BCA ASSESSMENT REPORT

Lots 33-35 & 43 Yarrunga Street, Prestons

Client: Logos Property Group

Revision 3

Figure 1 – Areas of Non-Compliant Perimeter Vehicular Access per BCA C2.4.

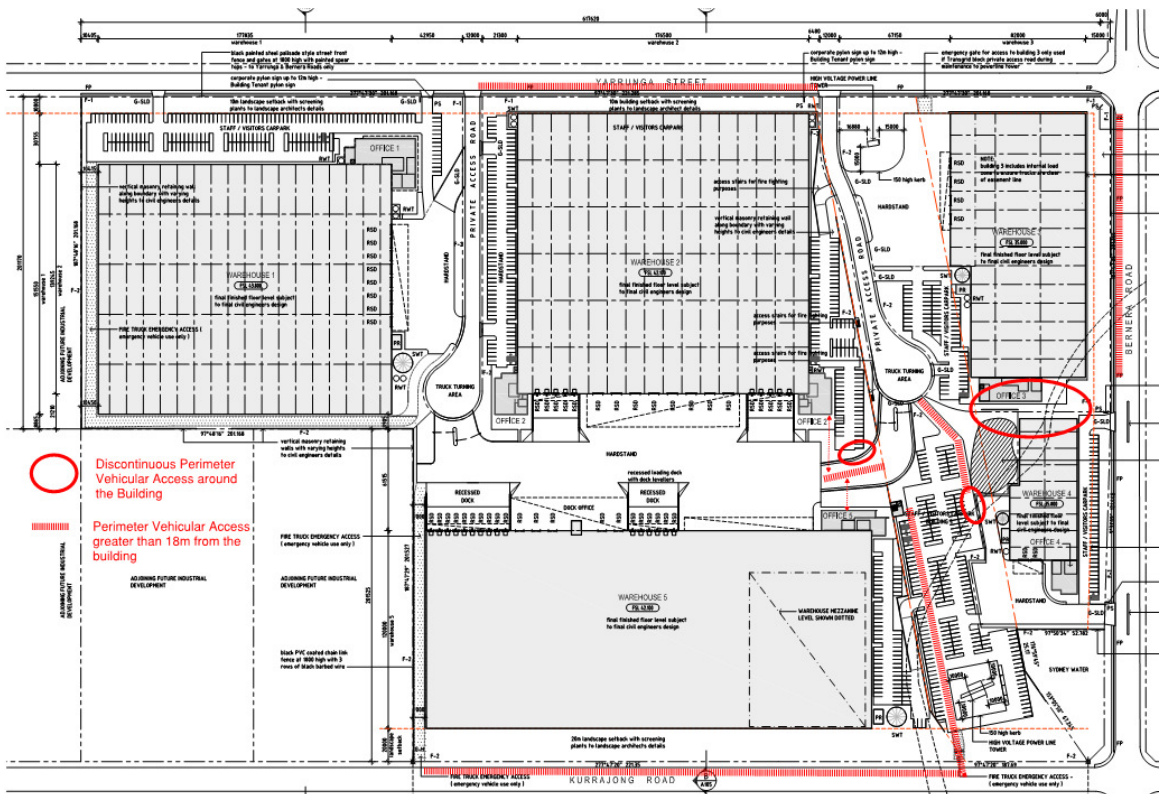
Comments: The proposed warehouse buildings do not comply with the provisions of C2.4 and thus the following non-compliance issues are required to be addressed as an alternative solution by the Fire Safety Engineer to demonstrate compliance with Performance Requirement CP9 - refer to the dot points and the diagram below for details of the proposed non-compliance issues:

- Vehicular Access is discontinuous between Warehouses 2, 4 & 5;- refer to diagram below.
- Vehicular Access is located greater than 18m from the external wall of the buildings in a number of locations around the site as indicated below.
